## **NOTICE OF PUBLIC MEETING**

## INSPIRED KIDS ACADEMY

**RE:** Inspired Kids Academy - Preliminary Plat and Site Plan

CITY OF VAN METER  
INSPIRED KIDS ACADEMY  
PRELIMINARY PLAT/SITE PLAN  
REVIEW COMMENTS

**DIMENSION PLAN**

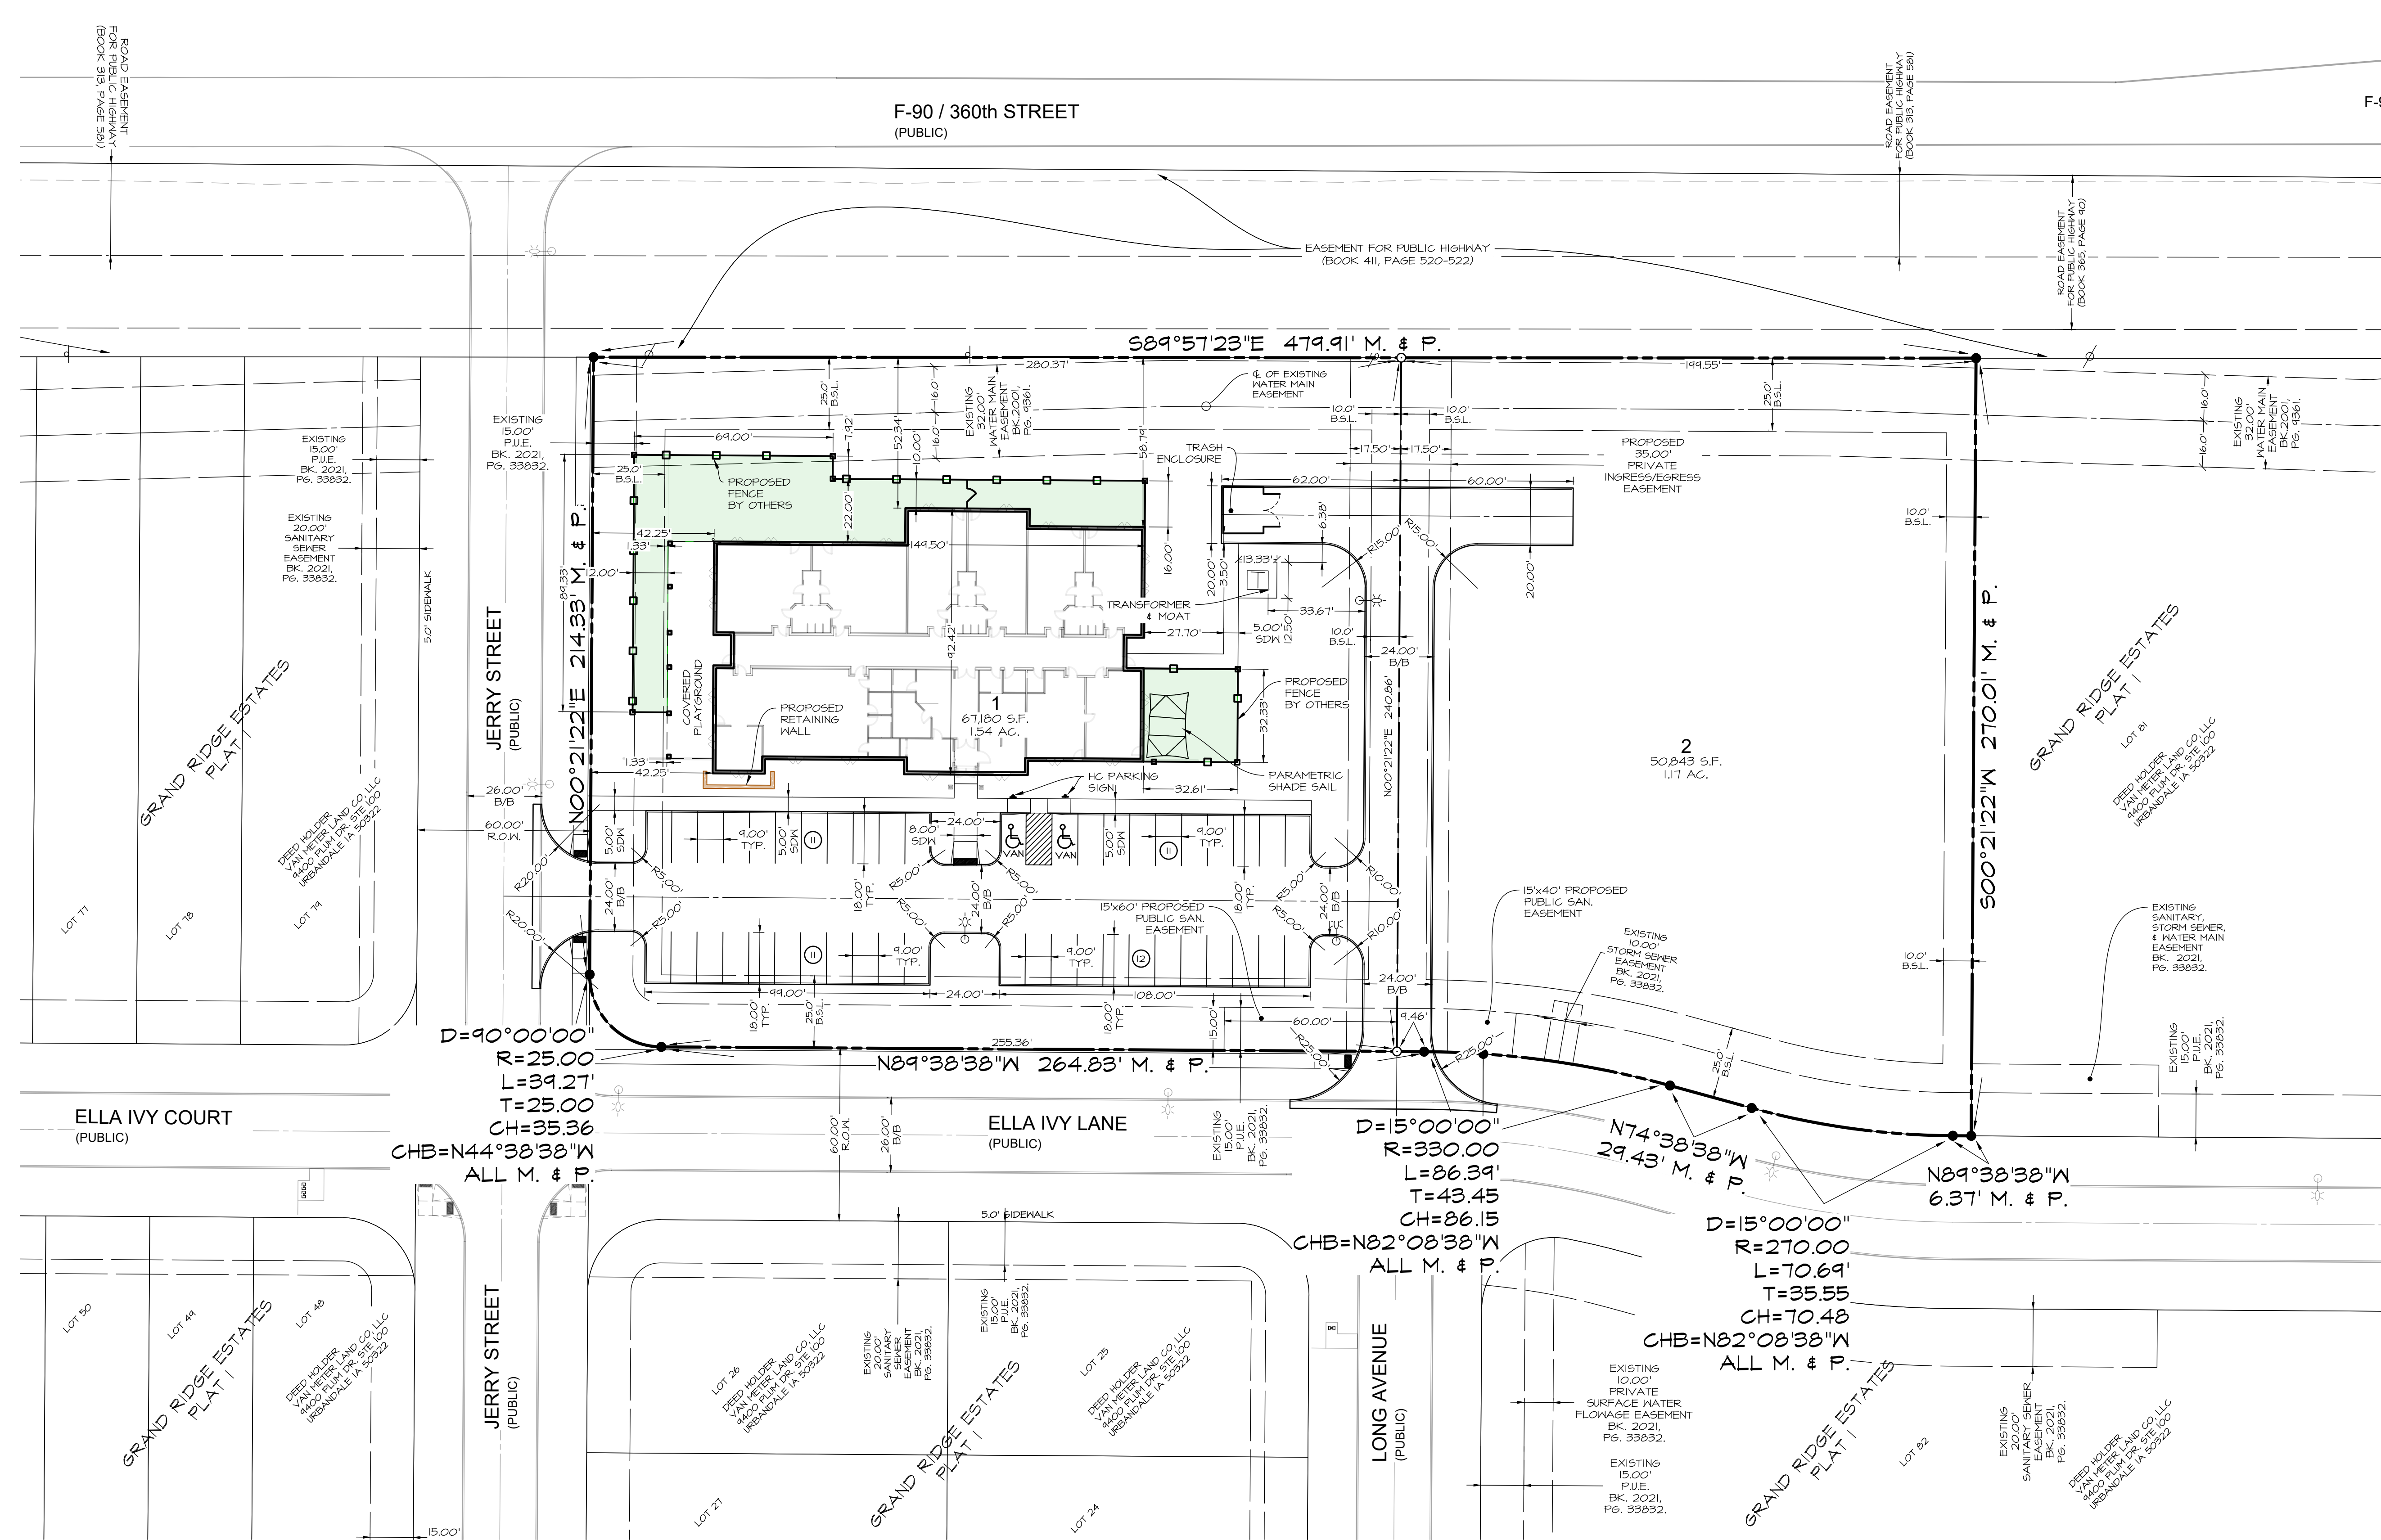
6. The site plan shows a driveway on Lot 1 connected to Jerry Street just to the north of Ella Ivy Lane. The separation distance between the driveway and intersection is marginal. Given the configuration of the lot a center of lot driveway does not appear practical. The driveway location closer to Ella Ivy Lane appears preferable to a location on the north side of the lot closer to the intersection of Jerry Street and F-90. The driveway location, although less than ideal, appears acceptable.

8. The site plan shows a shared drive for Lot 1 and Lot 2.
9. The preliminary plat/site plan shows a proposed ingress egress easement 35 feet in width straddling the lot line between Lot 1 and Lot 2. The shared access easement appears satisfactory relative to the north south shared drive.

11. The site plan should indicate the number of parking stalls provided. It is requested the site plan include the number of parking stalls and document compliance with the City's zoning ordinance relative to parking under 165.23.

**STORM SEWER PLAN**

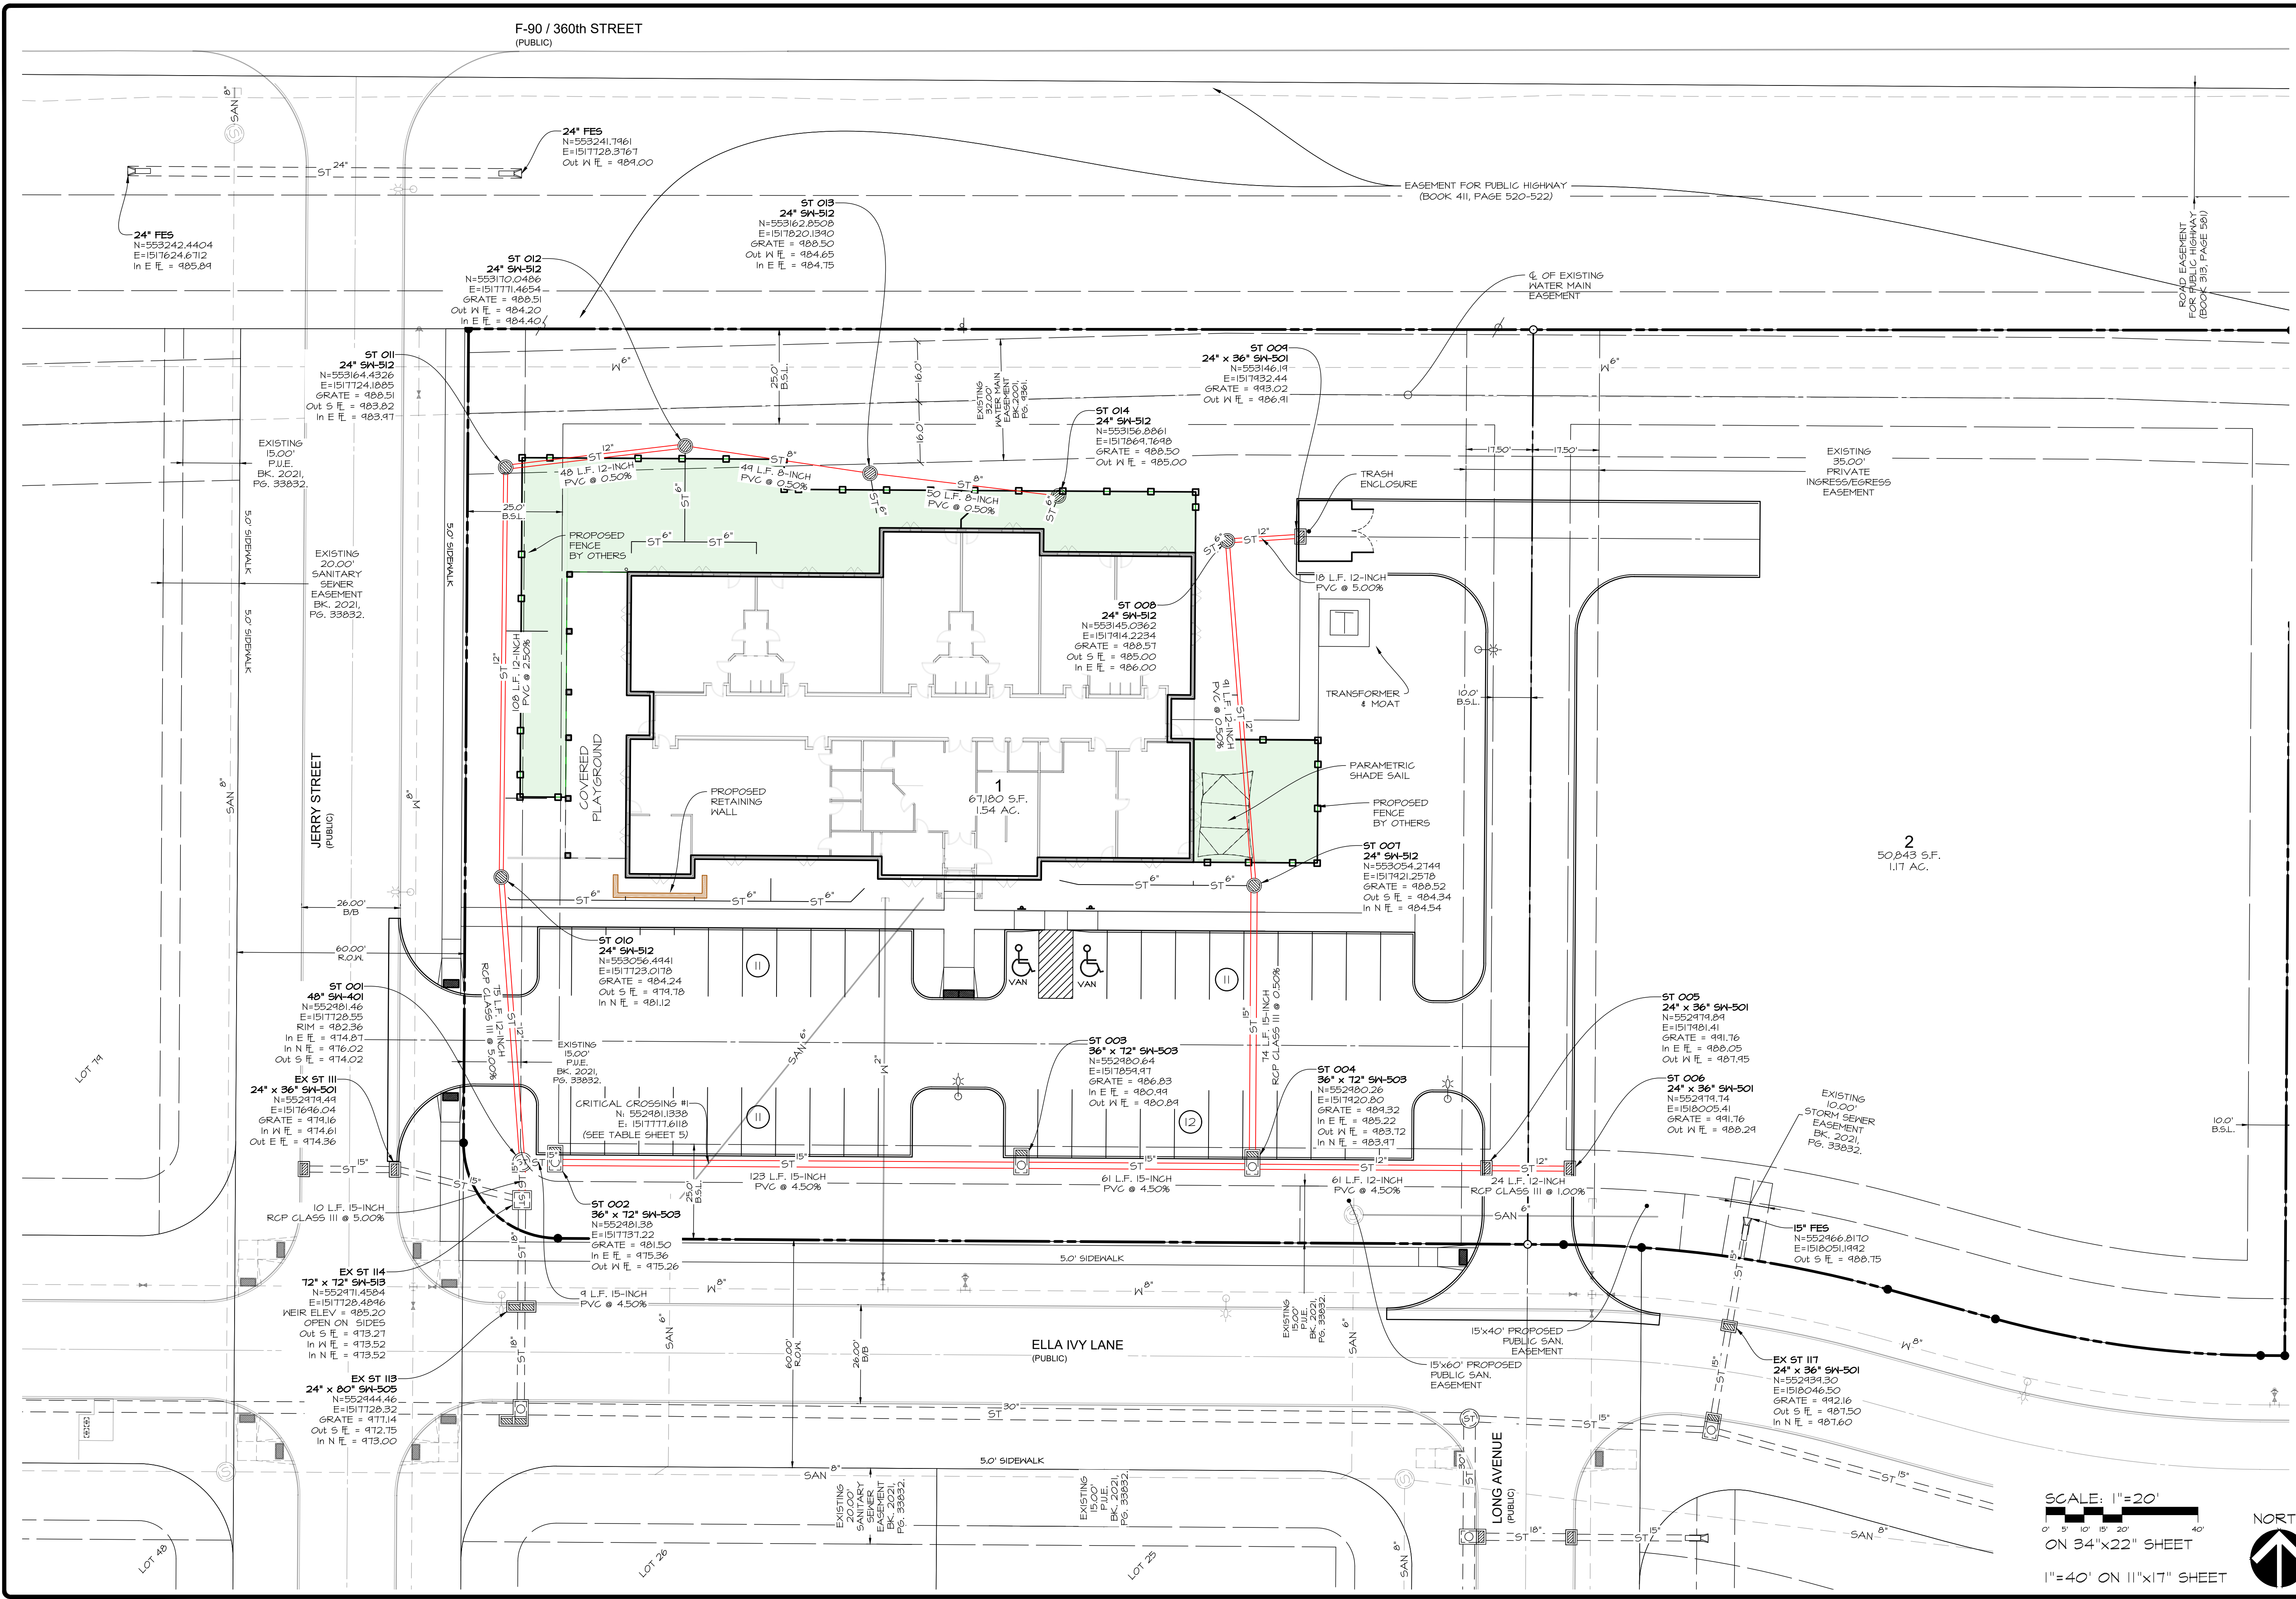
18. The site plan shows the storm sewer improvements within Lot 1. The outlet for the storm sewer is the existing storm sewer structure at the northeast corner of Jerry Street and Ella Ivy Lane.

19. The site plan includes a 12-inch storm sewer that extends north along the east side of Jerry Street and east along the north side of the proposed playground area.

20. The site plan shows a 15-inch storm sewer that extends east along the south side of the parking lot. This storm sewer includes one branch that continues east to the intakes located on the shared access drive and another storm sewer that extends north along the east side of the building.
